Product information - Brake pads | HELLA

Brake pads

8DB 355 011-401 / 8DB 355 015-961

Changed brake pads

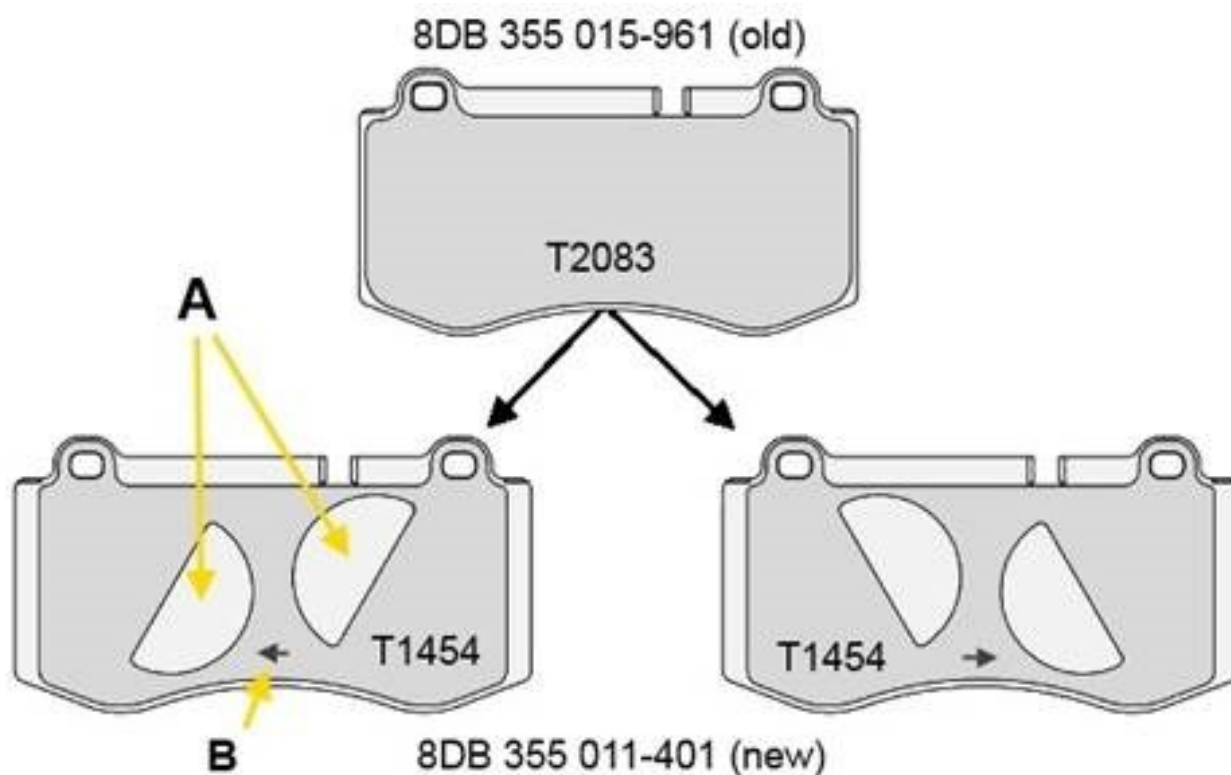
Brake pad 8DB 355 015-961 / T2083 will be replaced by brake pad 8DB 355 011-401 / T1454.

The difference between both brake pads is a change to the damping plate on the back plate of the brake pad. This change improves the noise sensitivity and thus, the comfort properties of the brake pads.

A new driving direction-related installation is necessary for the new damping plate with recess (A). The installation direction is indicated by an arrow (B).
